Loreto Kirribilli
IPC Briefing
11th September 2018

Loreto Kirribilli IPC Briefing DoP Conditions for discussion

Loreto Kirribilli Development Consent Condition B5 - Building Design

Figure 36: View of the roof from Unit 9/111 Carabella Street (Source: Applicant's RtS)

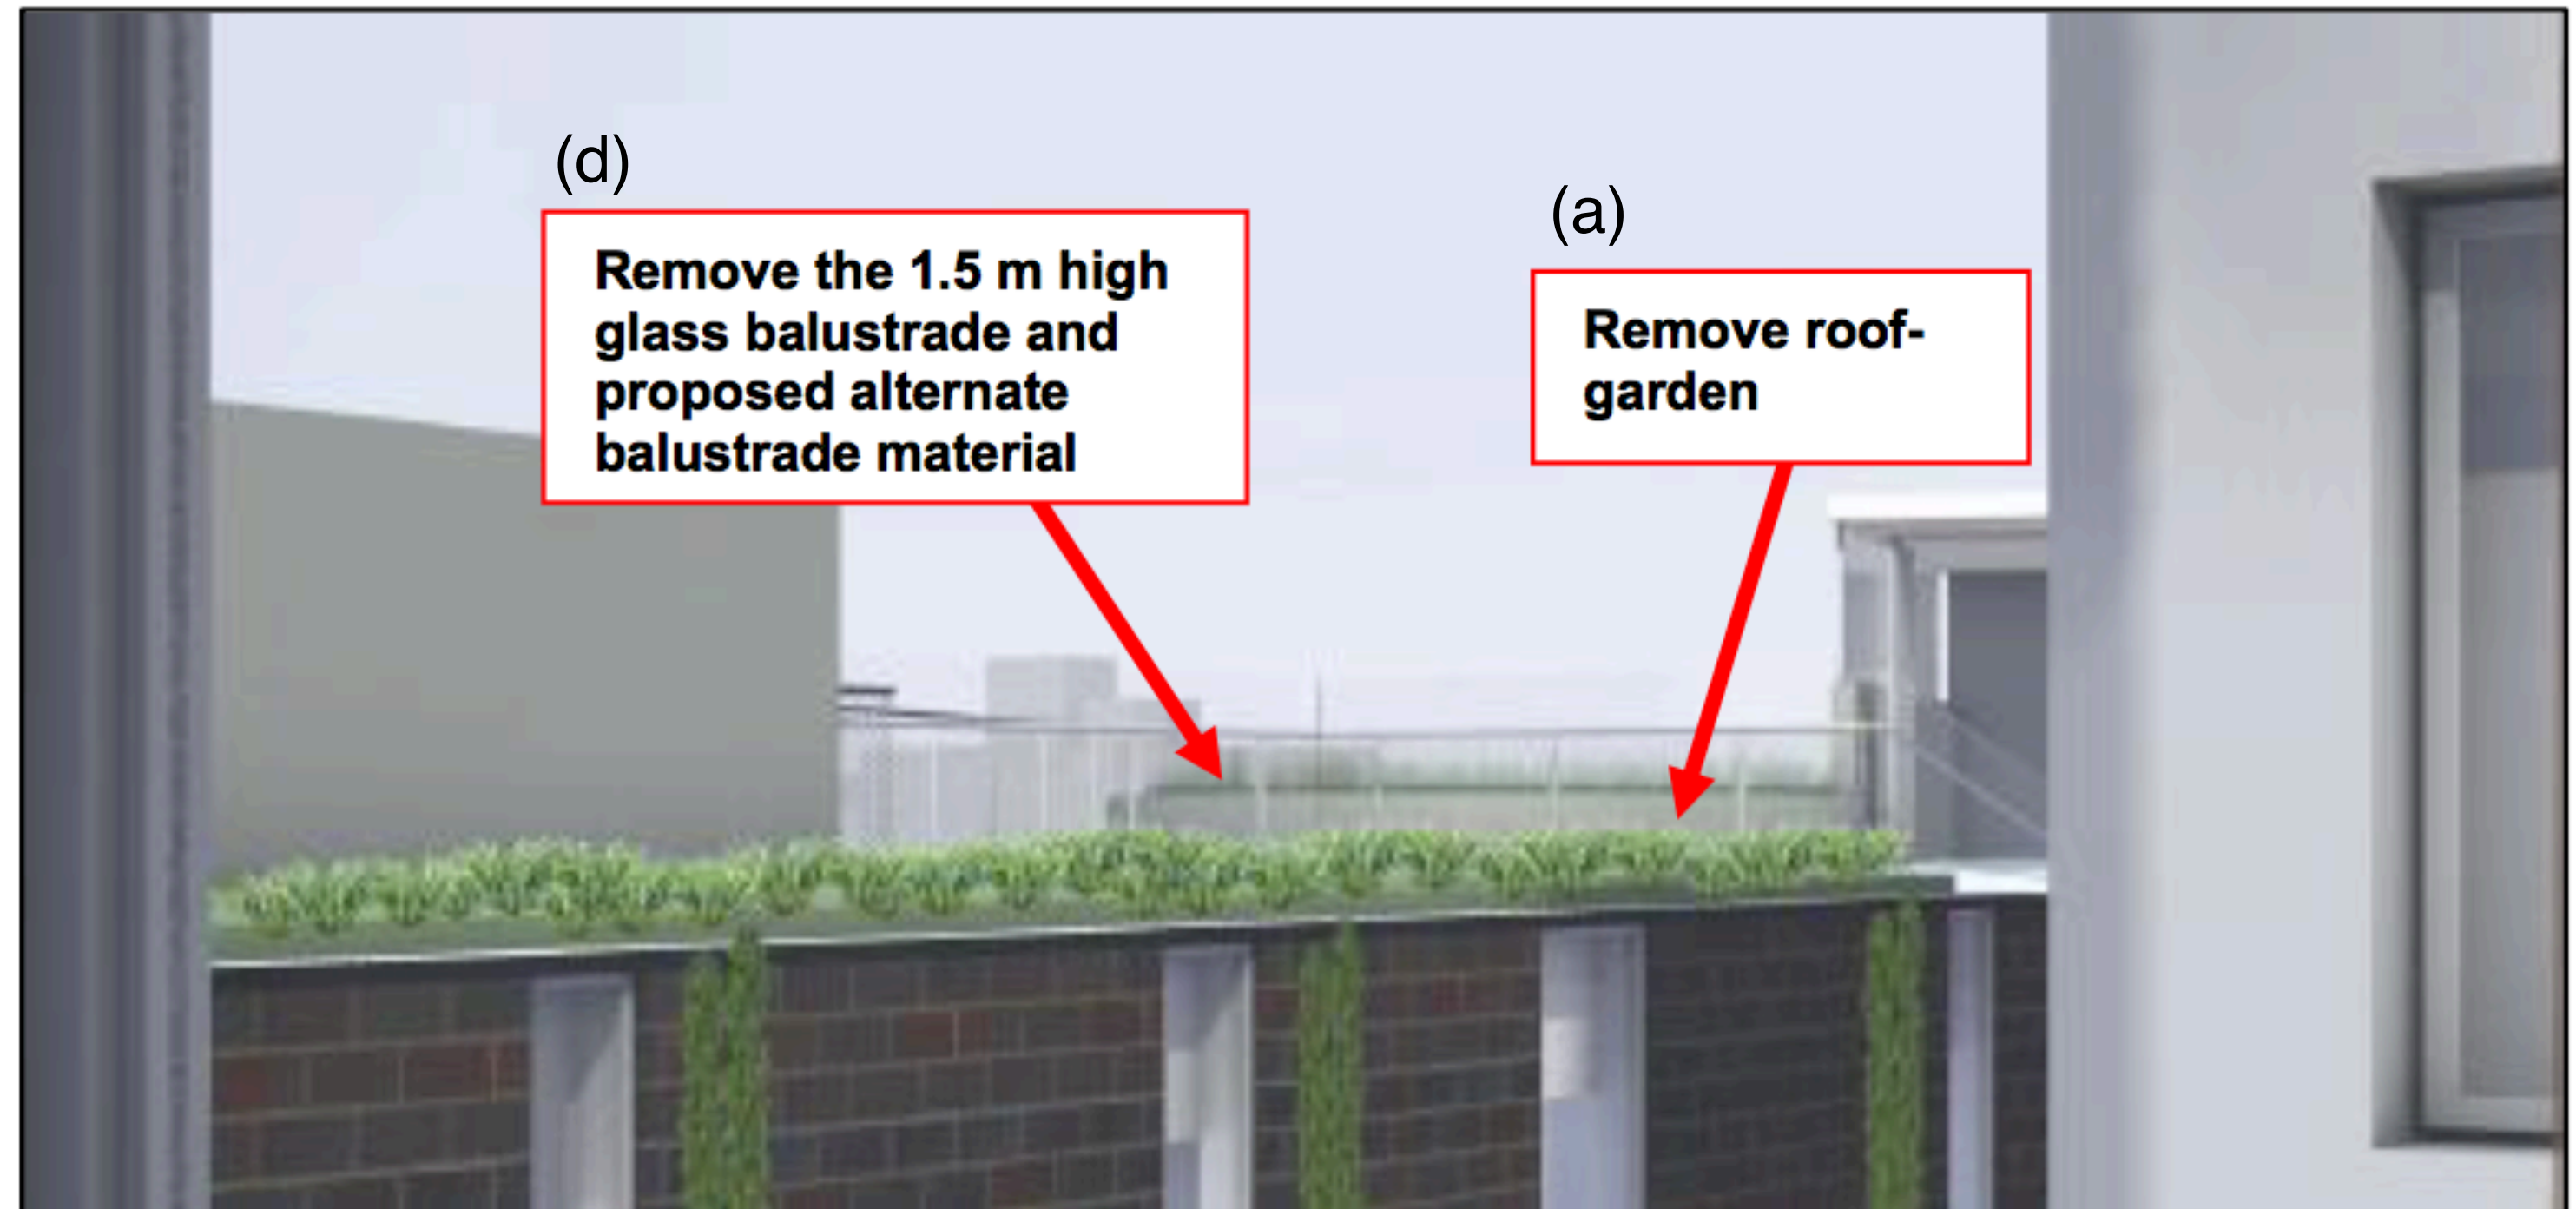
- (a) Delete the raised roof garden;
- (b) Floor level of the roof must not exceed FFL 34.5*;
- (c) Restrict any access to the roof above the learning hub except for maintenance and cleaning purposes only;
- (d) Remove the 1.5 m* high glass balustrade and propose alternative balustrades;
- (e) Access for circulation or fire egress purposes is restricted to the area between Marian Centre and the lift /stairs at the southern end only; and
- (f) Remove any lift opening on the northern side.

Loreto Kirribilli Unit 9/111 Carabella St - Proposed Learning Hub - Proposed DPE Amendments

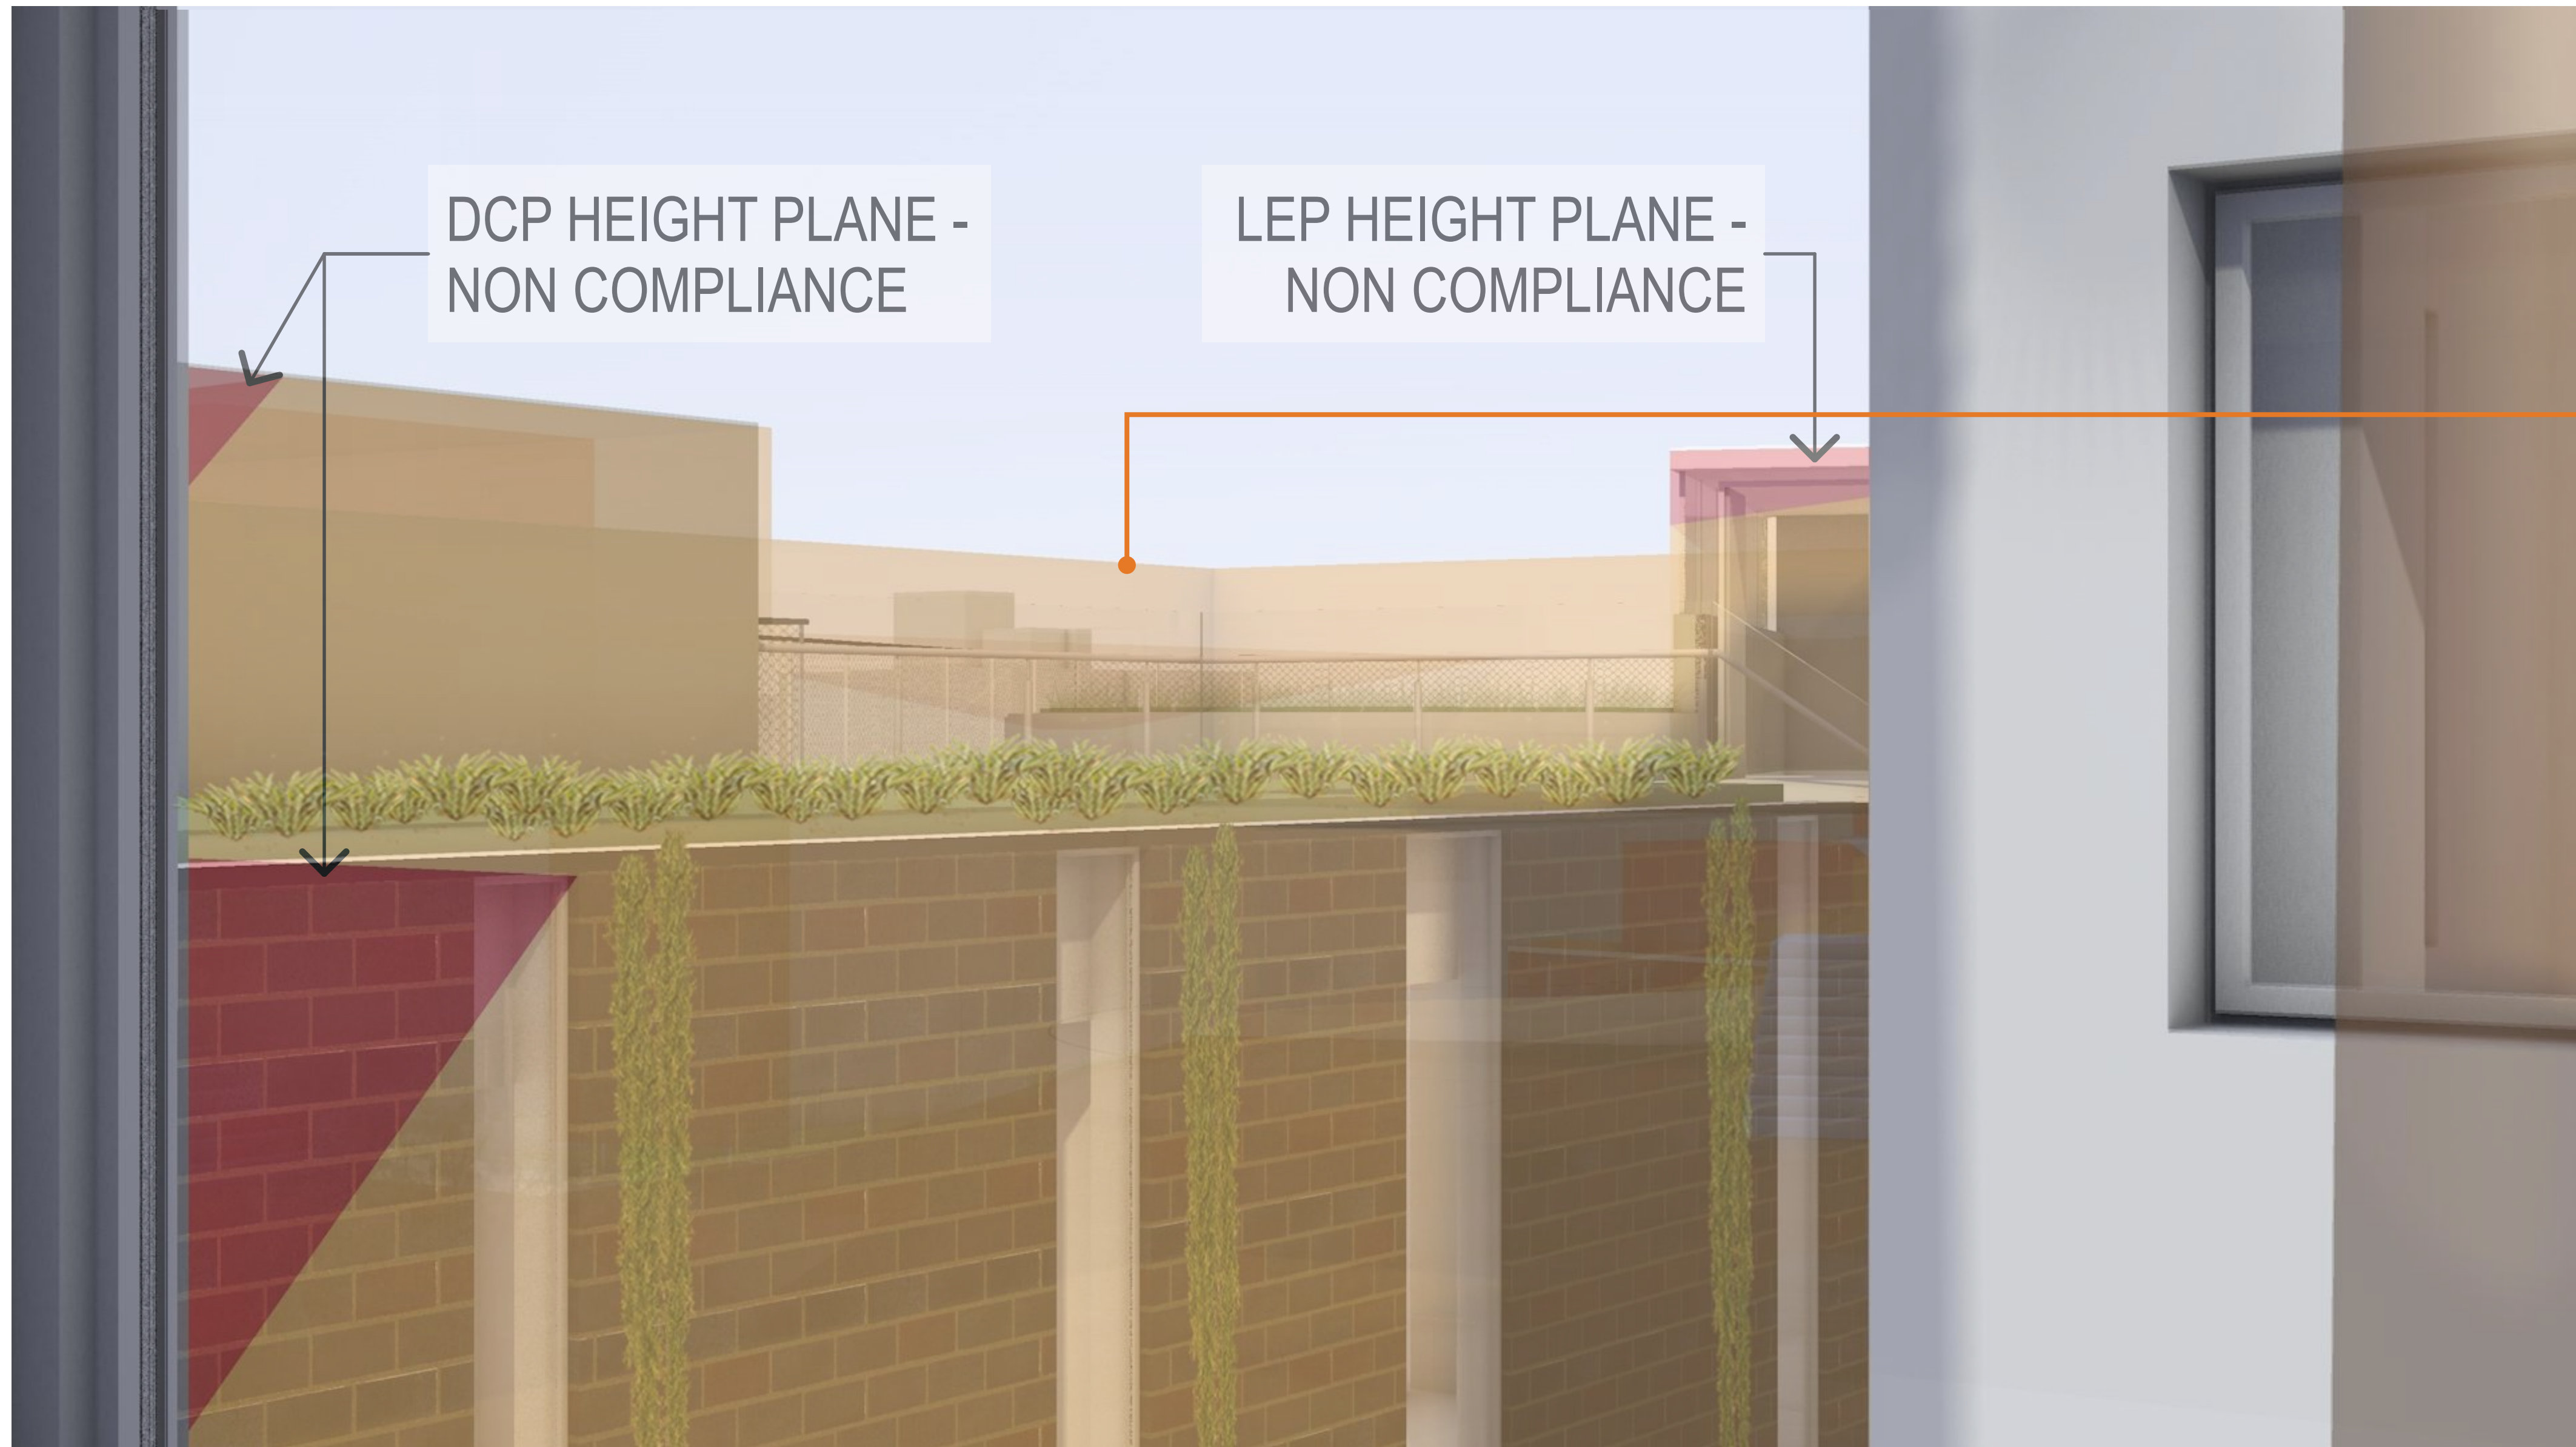
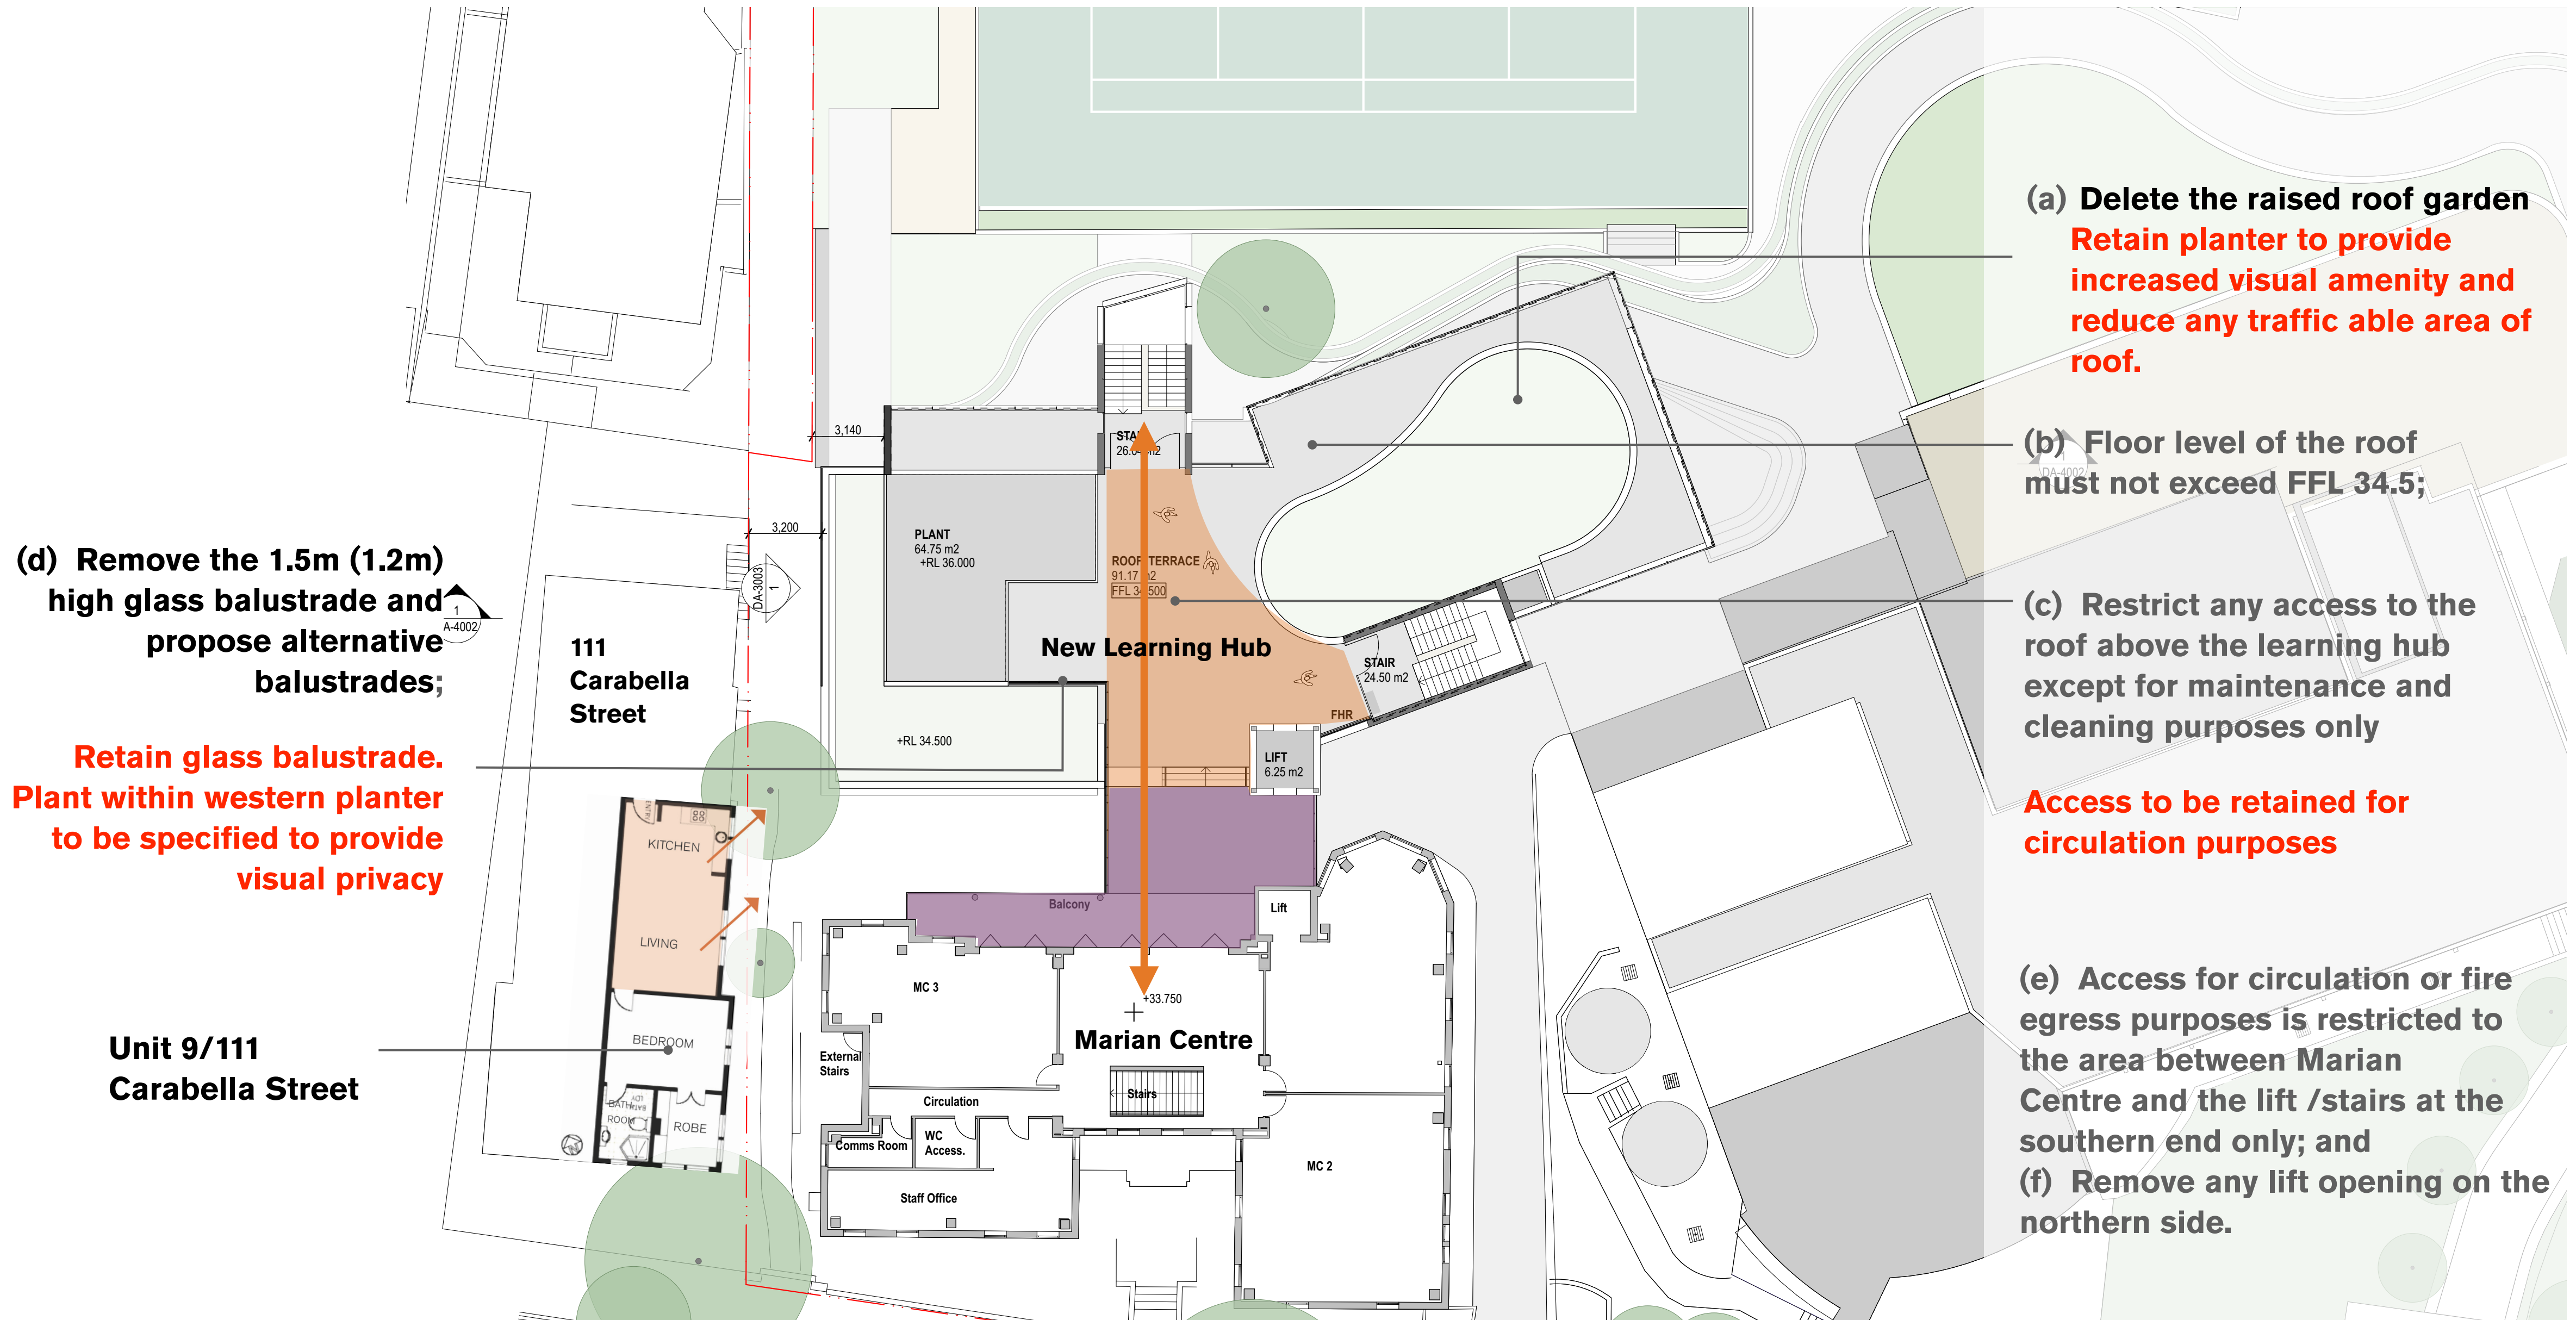
(a) Delete the raised roof garden

(d) Remove the 1.5m (1.2m) high glass balustrade and propose alternative balustrades;
